**RE: Inverness Water and Sanitation District
Inverness Lift Station No. 2
Addendum No. 1**

ADDENDUM NO. 1
to the
Bidding and Contract Documents
for the Construction of
INVERNESS WATER AND SANITATION DISTRICT
INVERNESS LIFT STATION NO. 2

SKETCH AD1-22
 10 OF 15

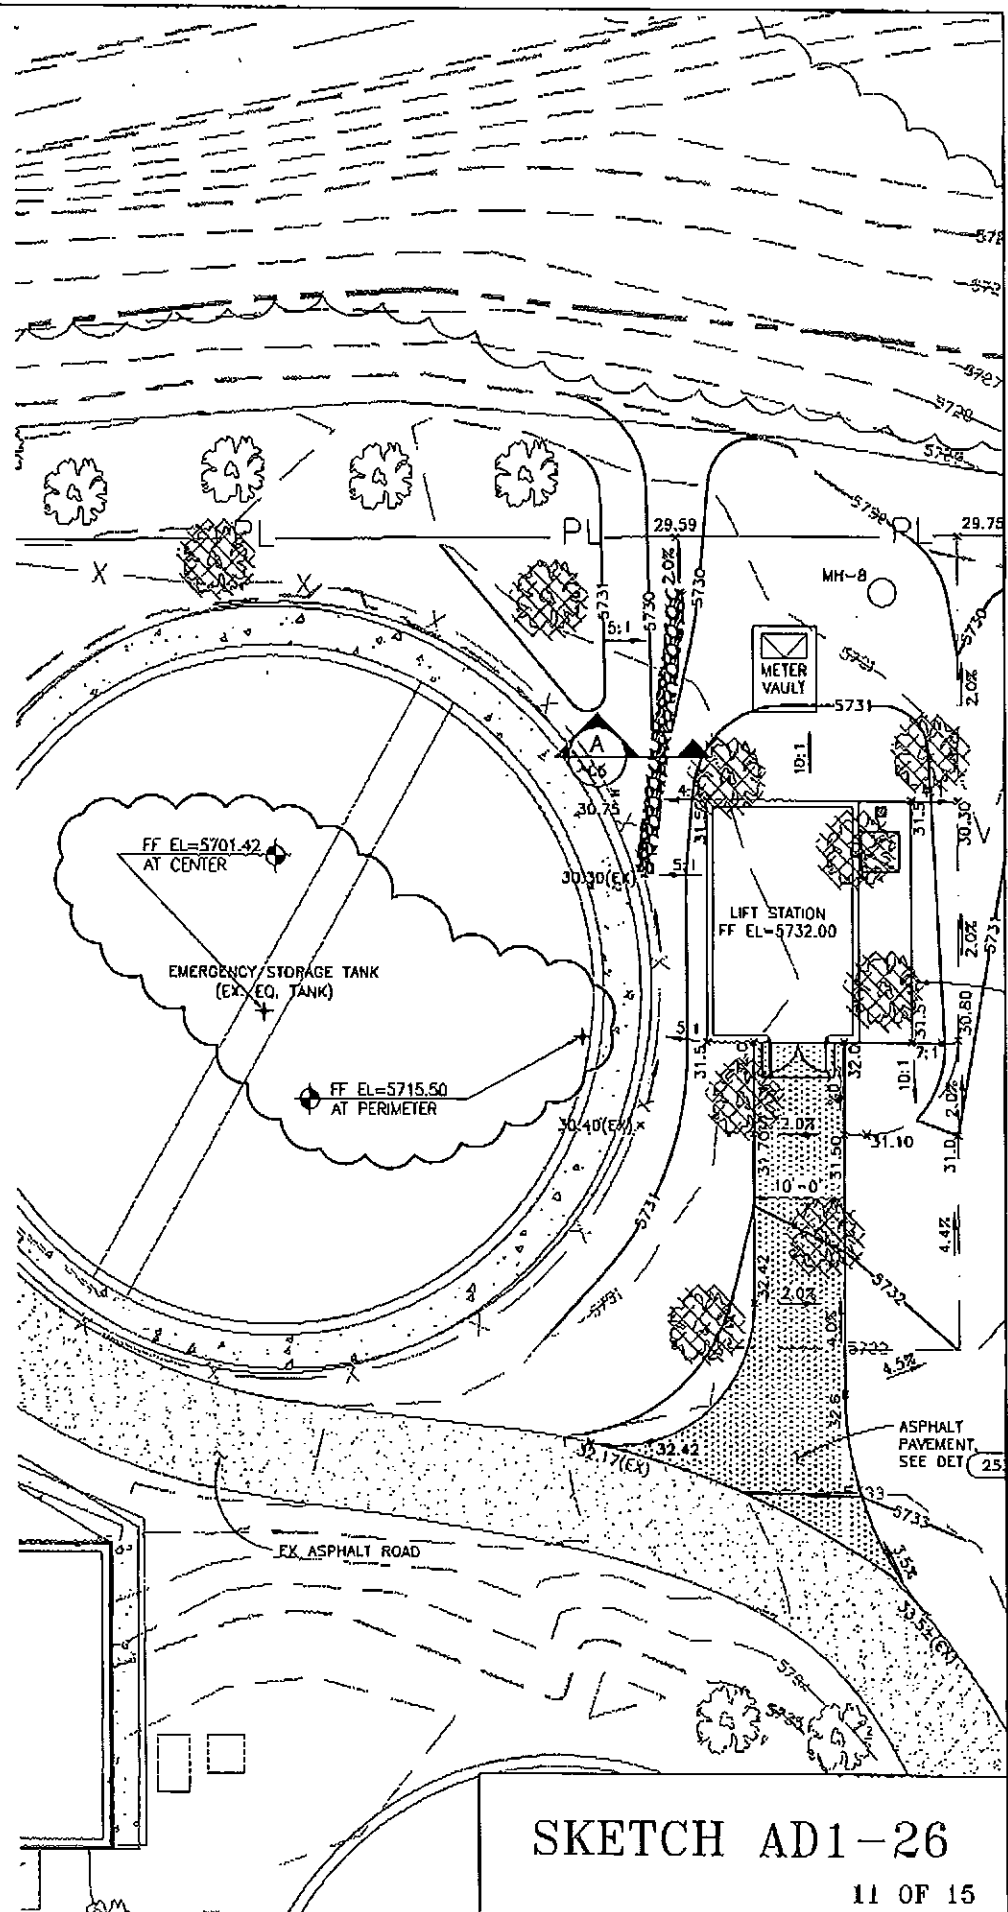
Addendum Number	Drawing Location	Addendum Item
AD1-22	Sheet No. G3, Drawing 3 of 57, Pipe Schedule	MODIFY the pipe schedule as shown in the attached Sketch AD1-22
AD1-23	Sheet No. C1, Drawing 6 of 57, Civil Legend	REPLACE the legend for easement with the following: <p align="center">-----EL----- or EASEMENT -----E/M-----</p>
AD1-24	Sheet No. C2, Sheet 7 of 57 (Note that this change also applies to Sheets C4 and C5)	ADD a callout pointing to the asphalt located adjacent to the double door on the East wall of the Lift Station as follows: "PROVIDE 5'x10' CONCRETE APRON/SITE EQUIPMENT PAD AS SHOWN ON SHEET A1, SEE DETAIL 3213"
AD1-25	Sheet No. C4, Drawing 9 of 57	ADD the following to Note: 3. NEW 6" W BY OTHERS WILL BE INSTALLED AFTER THE LIFT STATION IS BACKFILLED TO FINAL GRADE.
AD1-26	Sheet No. C5, Drawing 10 of 57, Site Grading Plan	ADD Elevations as indicated and clouded in Sketch AD1-26
AD1-27	Sheet No. A1, Drawing 11 of 57, Key Note 1	MODIFY Key Note 1 to read: "CONCRETE CURB AND/OR PAD BELOW EQUIPMENT, COORDINATE WITH PROCESS, STRUCTURAL AND ELECTRICAL DRAWINGS. VERIFY SIZE AND LOCATION WITH ACTUAL SIZE AND LOCATION OF EQUIPMENT, TYPICAL."

*FLOW STREAM IDENTIFIER *	SERVICE	INSTALLATION	*PIPE SIZE*	*PIPE MATERIAL*	*WALL THICKNESS OR CLASS*	*INTERIOR LINING*	*TEST PRES. & TYPE*	NOTES
EXH	GENERATOR EXHAUST	EXPOSED	<3 IN	-	-	-	NOT REQUIRED	
			≥3 IN	BLACK STEEL	SCH 40	-		
		BURIED	ALL	-	-	-		
FM	FORCE MAIN	EXPOSED	<3 IN	-	-	-	150 PSIG HYDRAULIC*	
			≥3 IN	DI	CL53	EPOXY		
		BURIED	ALL	-	-	-		
FOS	FUEL OIL SUPPLY	EXPOSED	<3 IN	COPPER/BLACK STEEL	SCH 40	-	75 PSIG COMPRESSED AIR	SEE FUEL OIL DIAGRAM SHEET MA FOR MATERIAL
			≥3 IN	-	-	-		
		BURIED	ALL	-	-	-		
FOR	FUEL OIL RETURN	EXPOSED	<3 IN	BLACK STEEL	SCH 40	-	75 PSIG COMPRESSED AIR	
			≥3 IN	-	-	-		
		BURIED	ALL	-	-	-		
FOV	FUEL OIL VENT	EXPOSED	<3 IN	GALV STEEL	SCH 40	-	5 PSIG OR 10 FT WC	
			≥3 IN	-	-	-		
		BURIED	ALL	-	-	-		
NG	NATURAL GAS	EXPOSED	ALL	BLACK STEEL	SCH 40	-	20 PSIG HYDRAULIC*	PLASTIC UNDERGROUND PIPE PER LOCAL UTILITY REQUIREMENTS
			ALL	-	-	-		
		BURIED	ALL	PE	-	-		
PDR	PROCESS DRAIN	EXPOSED	<3 IN	-	-	-	20 FEET HYDRAULIC*

≥3 IN	-	-	-		
		BURIED	<4 IN	PVC	SCH 80	-		
S	SANITARY SEWER	EXPOSED	<3 IN	PVC	SCH 80	-	20 FEET HYDRAULIC*	
			≥3 IN	-	-	-		
		BURIED	<3 IN	-	-	-		
SPD	BUMP PUMP DISCHARGE	EXPOSED	<3 IN	PVC	SCH 80	-	100 PSIG HYDRAULIC*	
			≥3 IN	-	-	-		
		BURIED	<3 IN	-	-	-		
W	POTABLE WATER	EXPOSED	<3 IN	COP	TYPE L	-	150 PSIG HYDRAULIC*	
			≥3 IN	-	-	-		
		BURIED	<3 IN	COP	TYPE K	-		
			≥3 IN	DI	CL51	CEMENT

SKETCH AD1-33

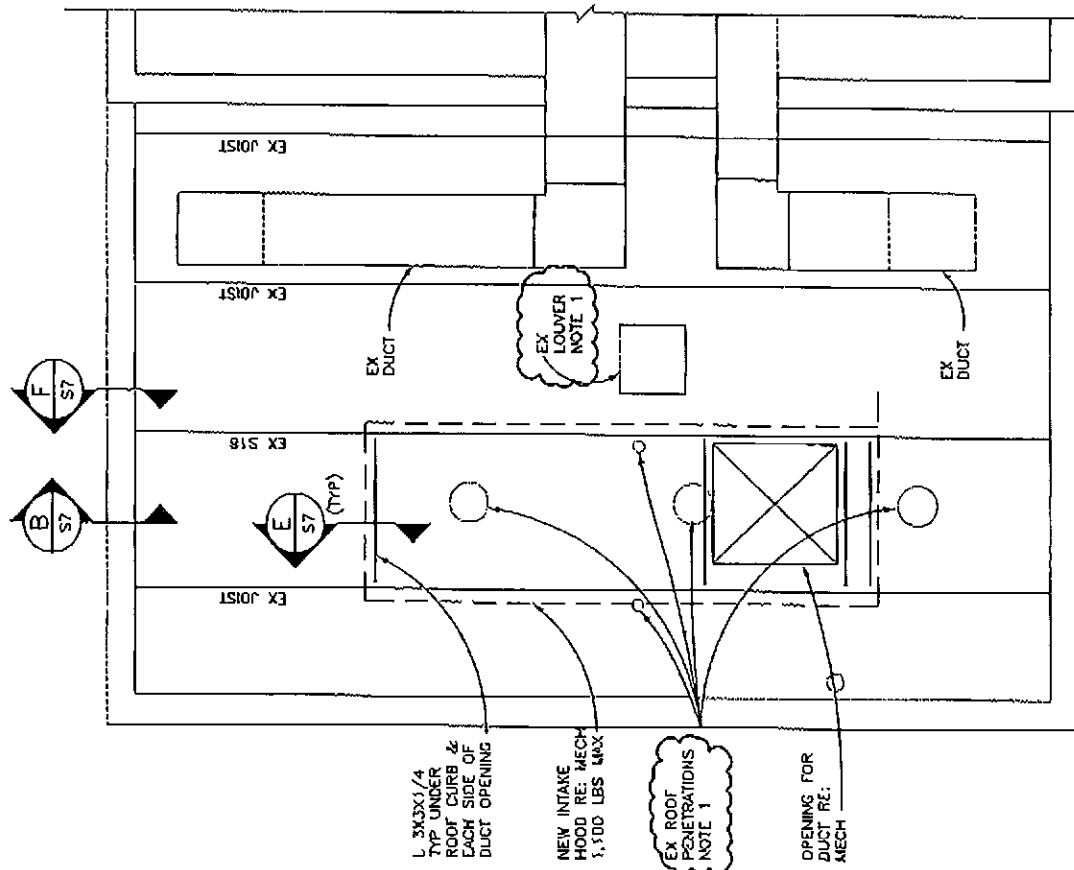
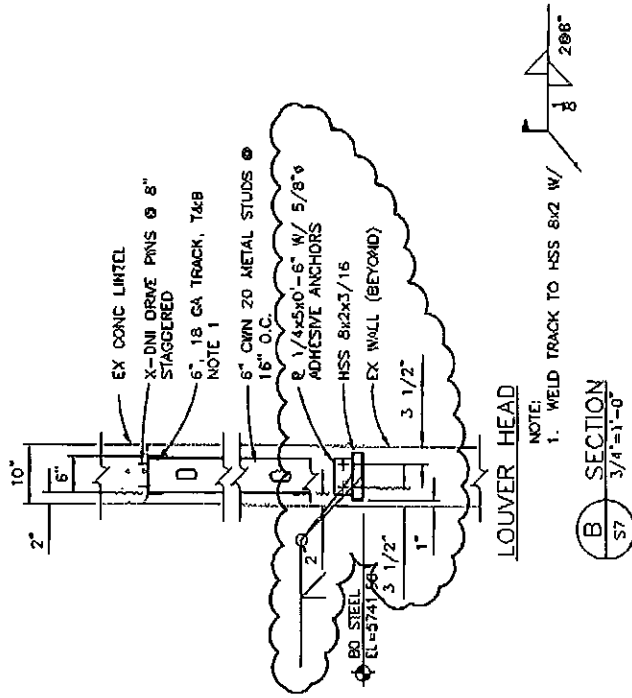
Addendum Number	Drawing Location	Addendum Item
AD1-32	Sheet No. A3, Drawing 13 of 57, Key Note 8	MODIFY Key Note 8 to read as follows: "LIGHT FIXTURE, MOUNT 8'-6" ABOVE FINISH FLOOR, RE: ELEC"
AD1-33	Sheet No. A5, Drawing 15 of 57	ADD Detail 4/A5 as shown in Sketch AD1-33
AD1-34	Sheet No. A5, Drawing 15 of 57, Key Note 4	MODIFY Key Note 4 to read as follows: "PRECAST CONC DOUBLE TEES, RE: 4/A5 TYPICAL"
AD1-35	Sheet No. A7, Drawing 17 of 57, Key Note 5	MODIFY Key Note 5 to read as follows: "EXTENT OF ROOF PATCH AND REPAIR. INFILL INSULATION AND COVER BOARD AS REQUIRED TO ALIGN WITH EXISTING ADJACENT."
AD1-36	Sheet No. A7, Drawing 17 of 57, Key Note 9	MODIFY Key Note 9 to read "...3/8" CEMENT BOARD..." in lieu of "...1/2" CEMENT BOARD...".
AD1-37	Sheet No. S1, Drawing 18 of 57	ADD Notes to Typical Earthwork at Lift Station as follows: NOTES: 1. DO NOT SCARIFY BEDROCK BELOW MAT FOUNDATION. 2. IF BEDROCK IS NOT ENCOUNTERED AT THE ELEVATION OF THE BOTTOM OF MAT FOUNDATION, EXTEND EXCAVATION TO BEDROCK AND BACKFILL WILL FLOW FILL.

CUT MASONRY NEATLY
 AROUND TEE STEM.
 HOLD GAP TO 1/2"
 BTWN TEE & MASONRY,
 SEAL GAP, TYP

SEAL GAP BTWN EMBED
 PLATE & MASONRY WALL,
 PAINT EXPOSED STEEL, TYP

TEE LEG BRG ON MASONRY
 WALL, SEE STRUCT DWGS, TYP.

SKETCH AD1-40

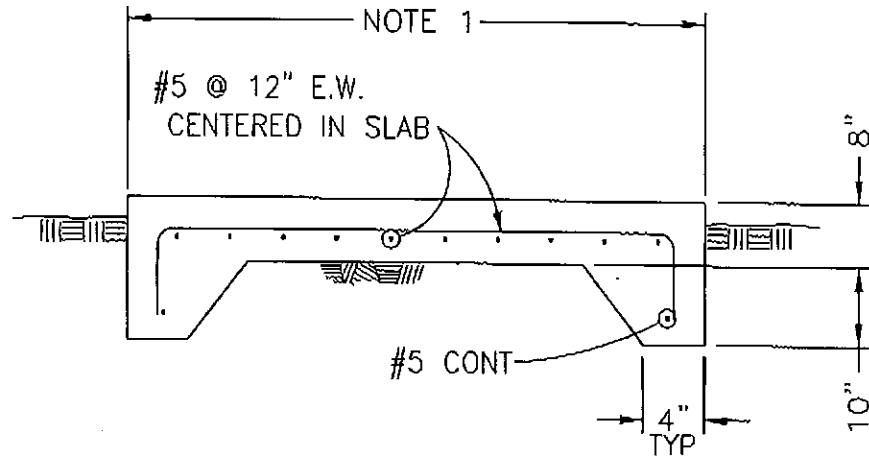
AD1-38	Sheet No. S7, Drawing 24 of 57, Roof Plan and Section B	MODIFY the Roof Plan and Section B as indicated and clouded in Sketch AD1-38
AD1-39	Sheet No. P5, Drawing 29 of 57, Section A	MODIFY "2" AUTOMATIC AIR RELEASE VALVE (TYP OF 2)" to read "2" COMBINATION AIR VALVE FOR SEWAGE (TYP OF 2)".
AD1-40	Sheet No. M4, Drawing 35 of 57, Generator Exhaust Detail	REPLACE the Generator Exhaust Detail in its entirety with detail shown in Sketch AD1-40

THIMBLE O.D. SHALL BE 12 INCHES IN
DIAMETER LARGER THAN EXHAUST PIPE
ASSEMBLY IN ACCORDANCE WITH
NFPA-37 SILEX EXHAUST SYSTEMS OR
EQUAL.
